West Gate Tunnel Project IAC

West Gate Tunnel Project

Environmental Effects Statement
Hobsons Bay City Council Submission

July 2017

Appendix I (1)

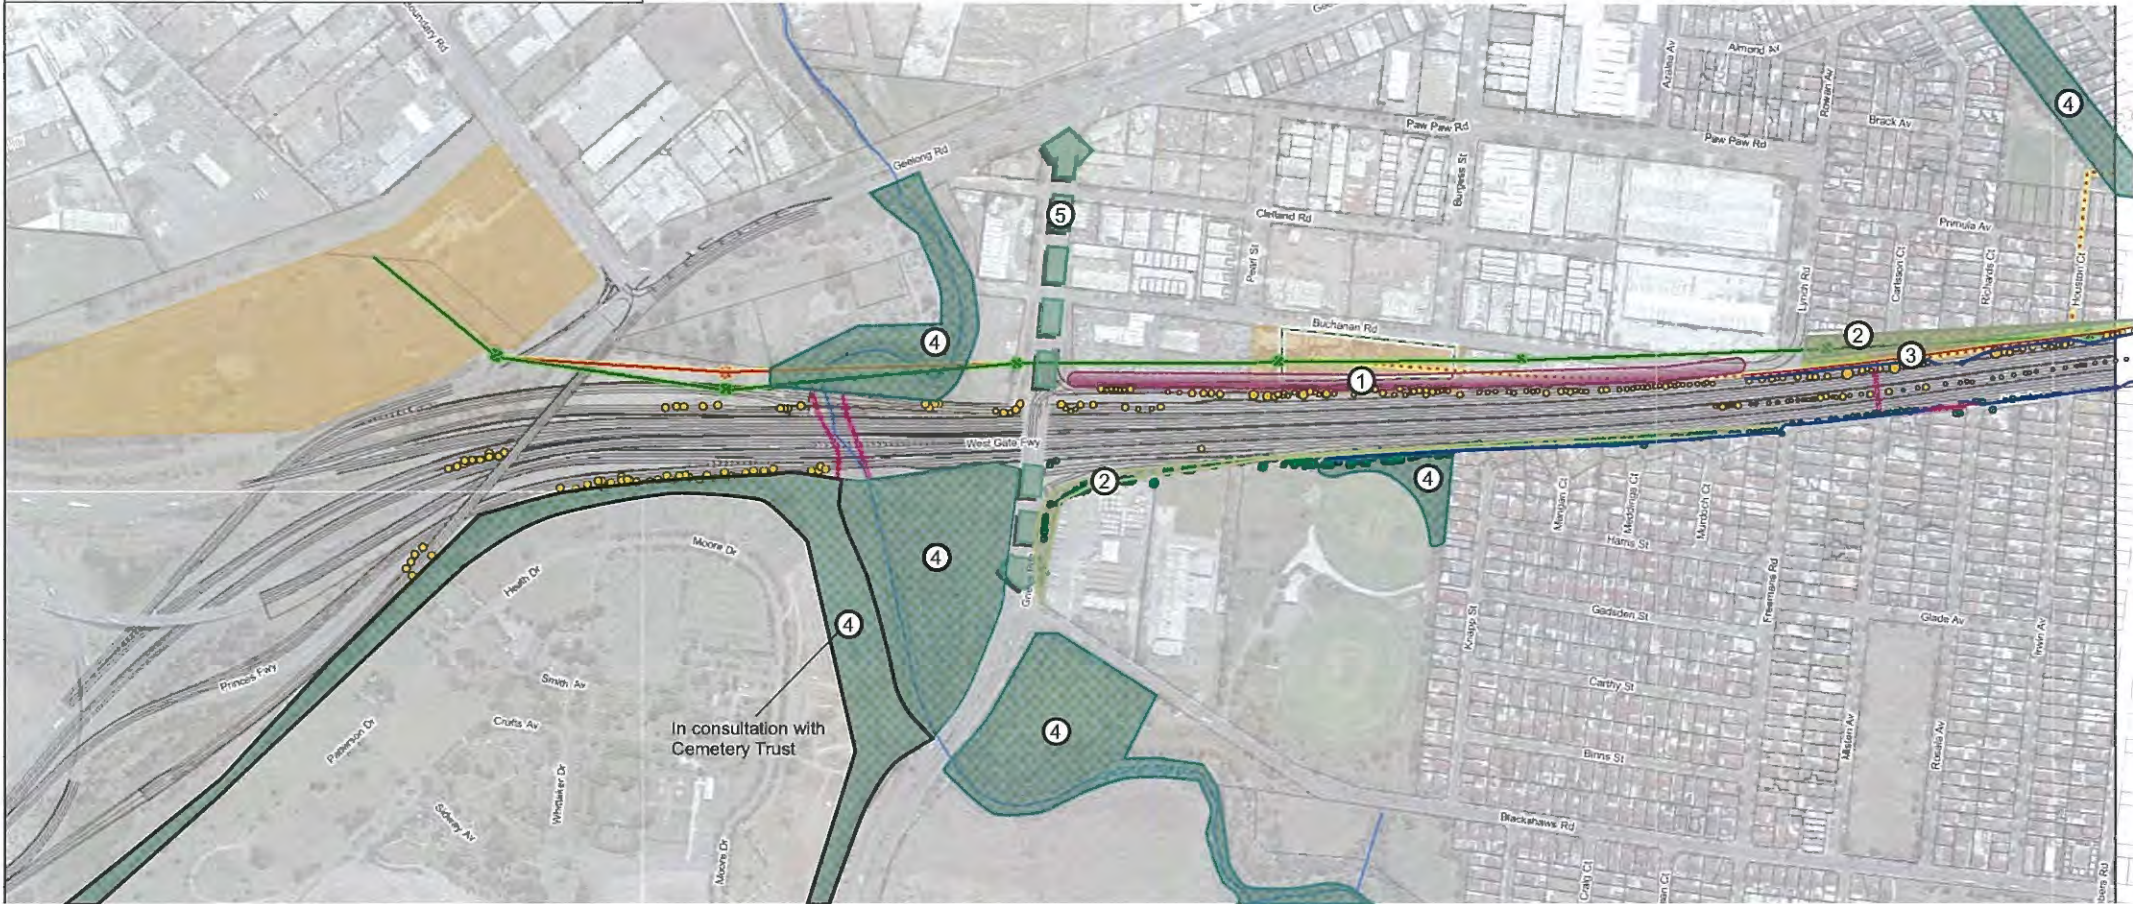
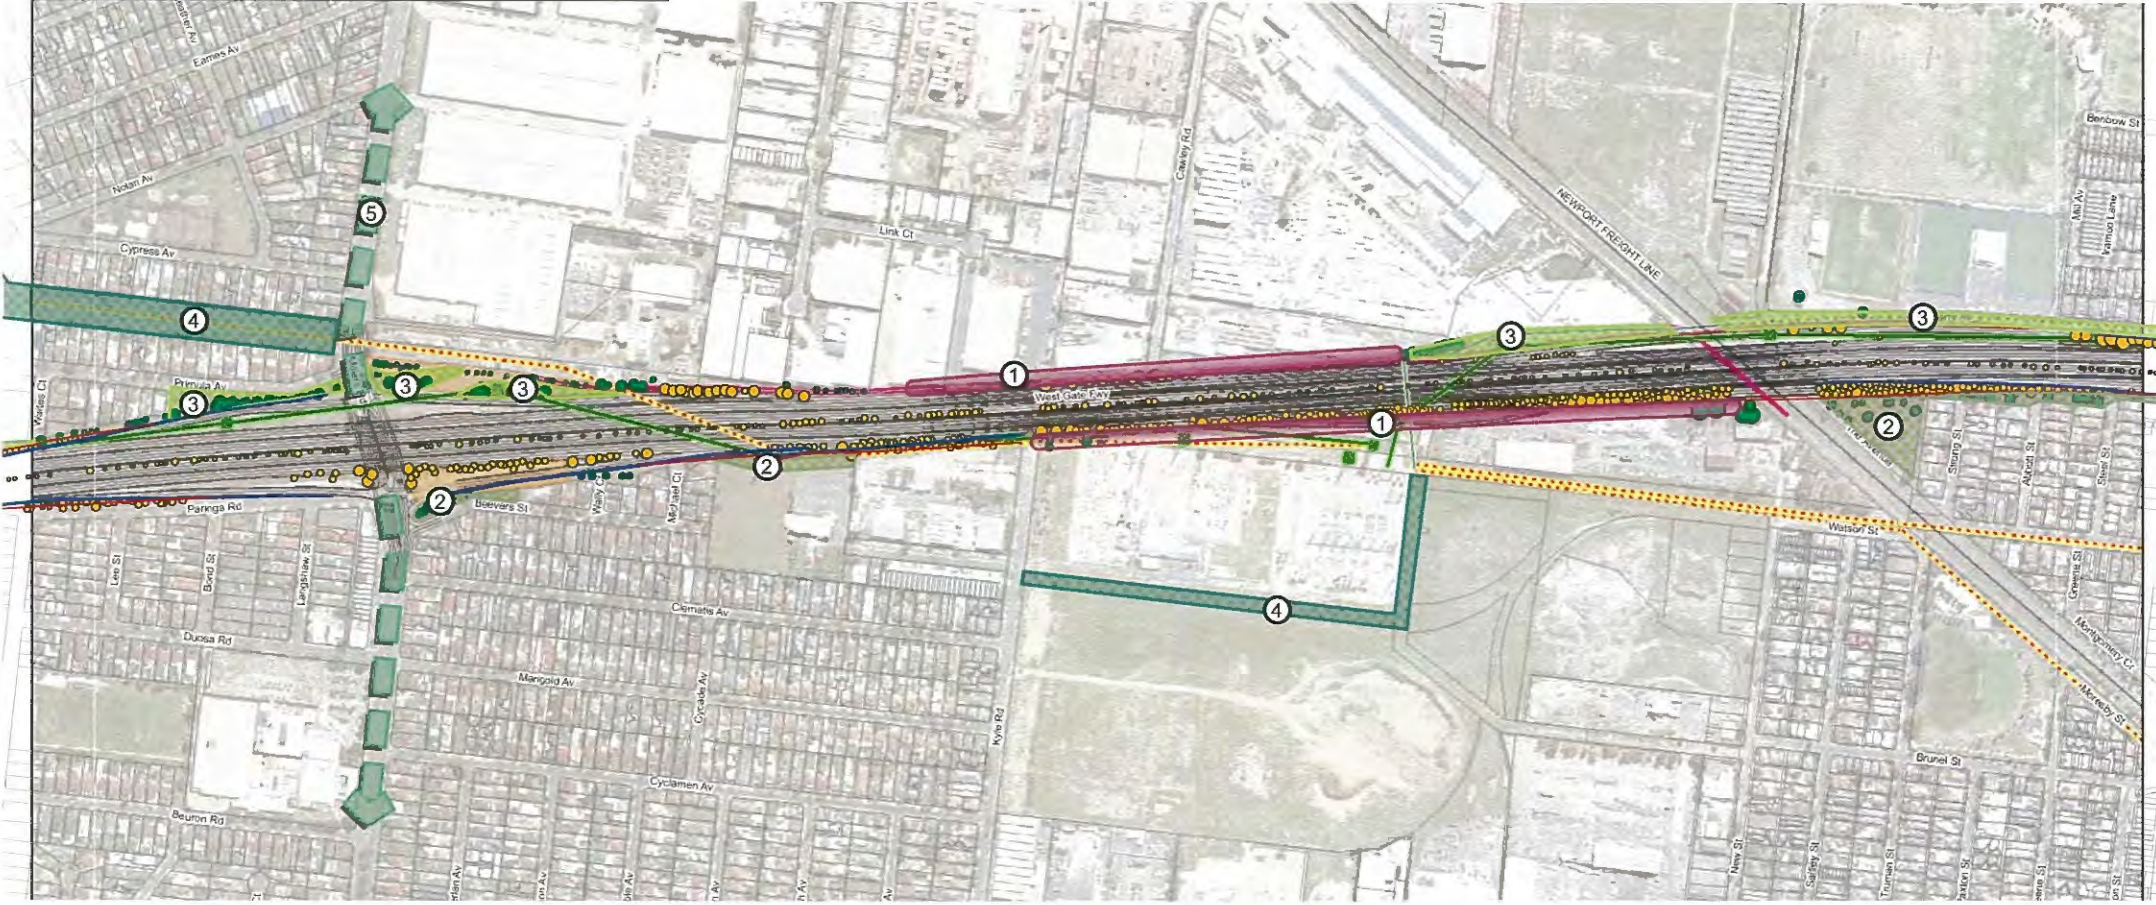
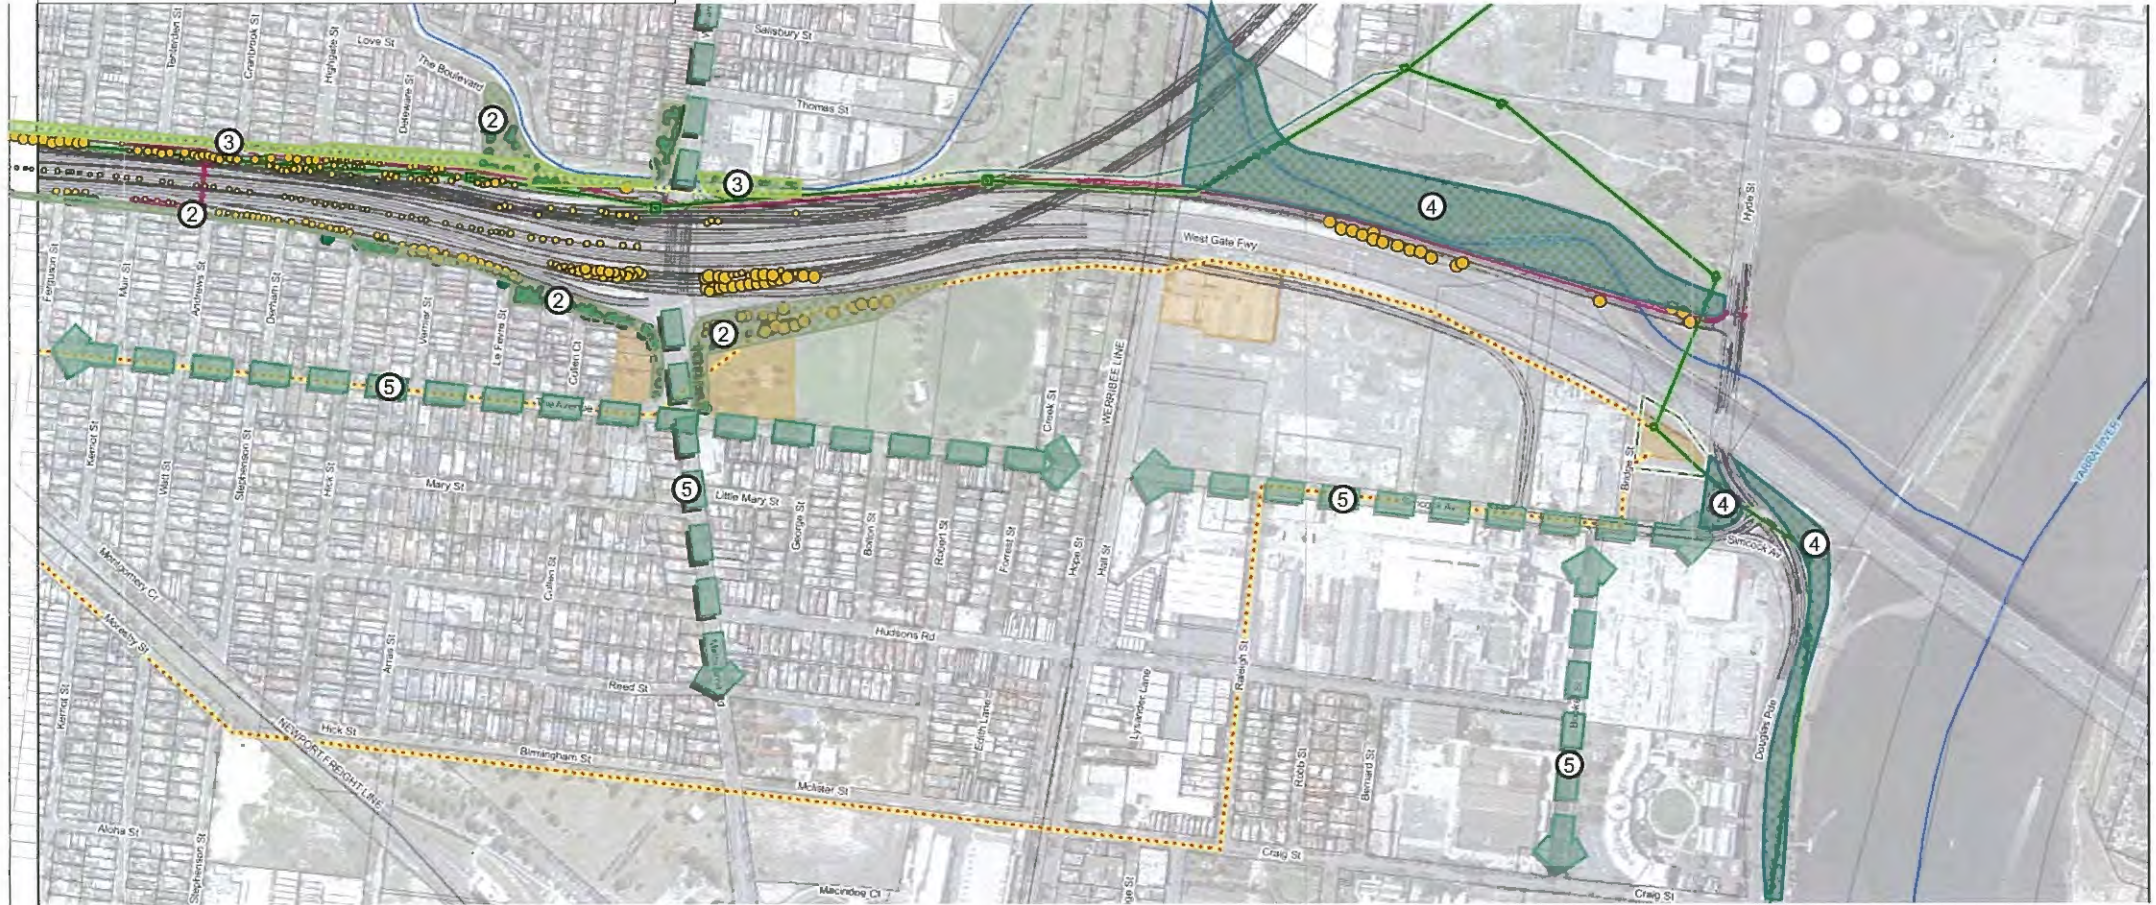
Council's Vegetation Loss and Offset Opportunities Plan (Appendix I) identifies suitable locations for offset amenity planting along the Freeway corridor which is consistent with Masterplans for Kororoit Creek and Don McLean Reserve and the Draft HBCC Urban Forest Strategy (currently in development). This Plan includes locations of current unused remnant land along the Freeway that could be planted and also references locations identified through Greening the West.
